STAFF REPORT

AGENDA ITEM: Final Plat and Planned Unit Development (PUD) Plans and Conditional Use

Permit for Day Care Facility to be called Growing Explorers Learning Center

The City has received a set of applications from Shamsi, LLC for Final Plat and PUD Plans and a conditional use permit for Outlot A of Boulder Ponds.

LANDSCAPE PLAN

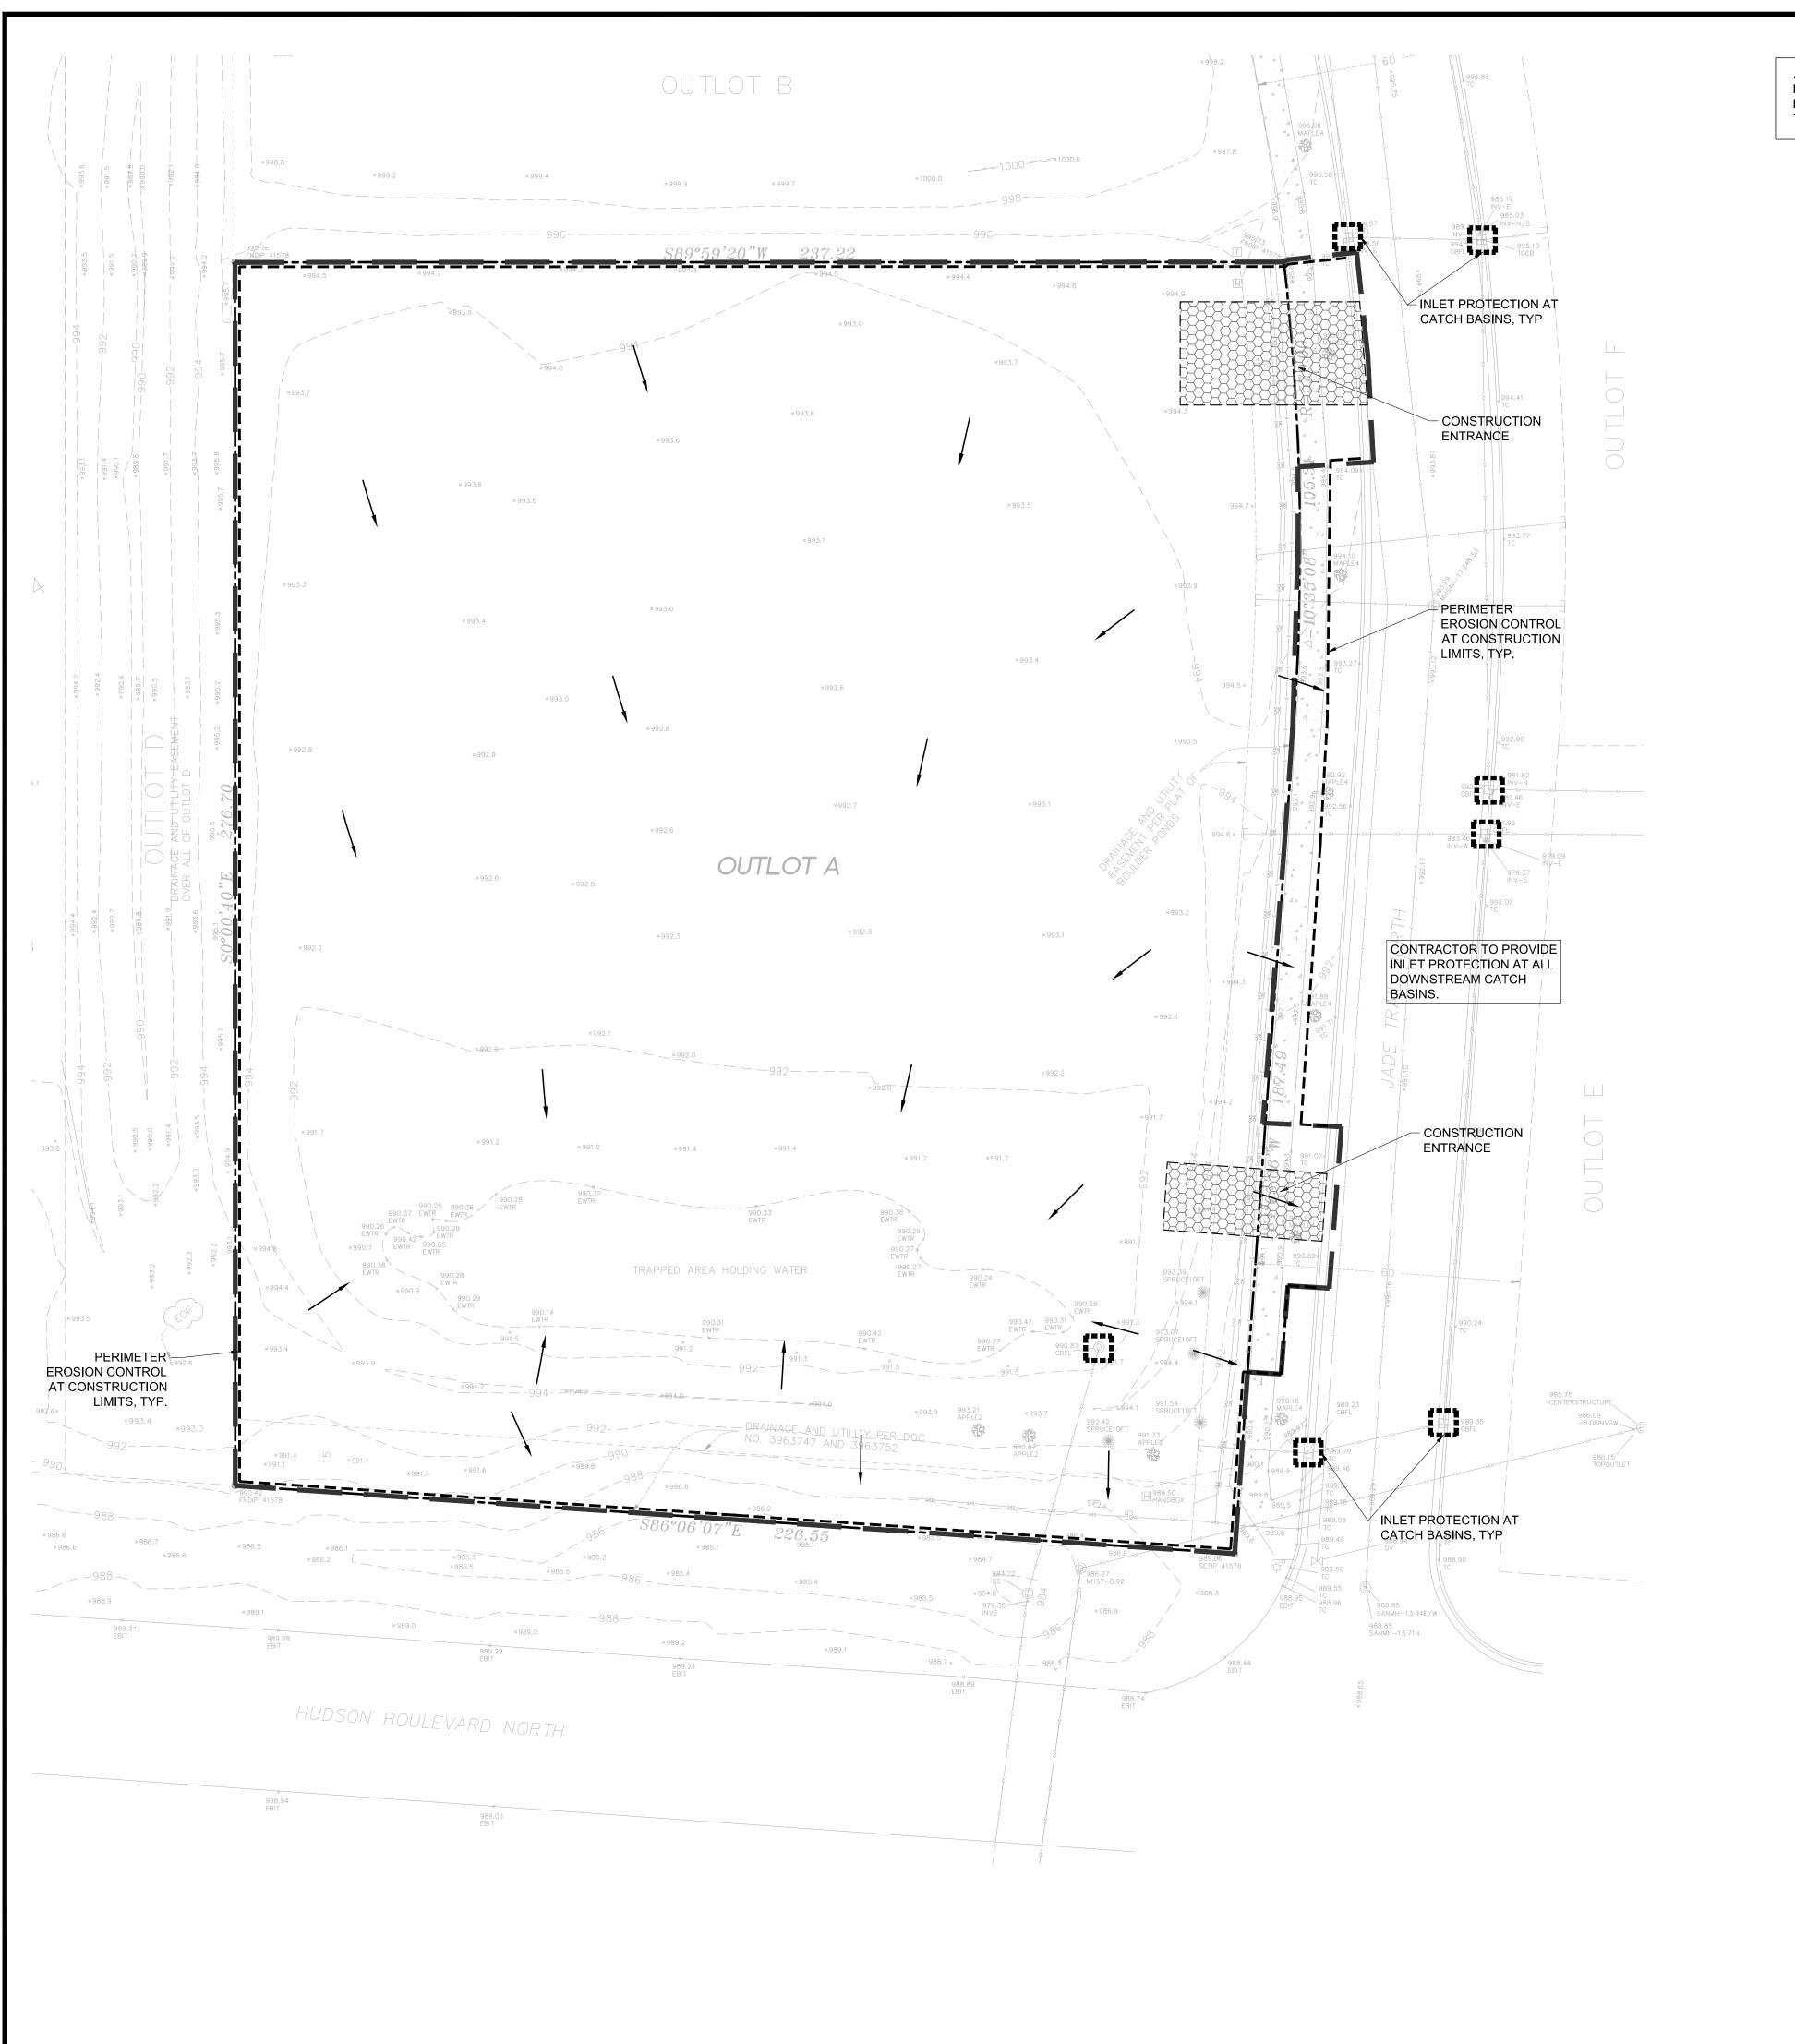
• The submitted landscape plan does not include the required number of trees, as 19 are required, and 16 are proposed.
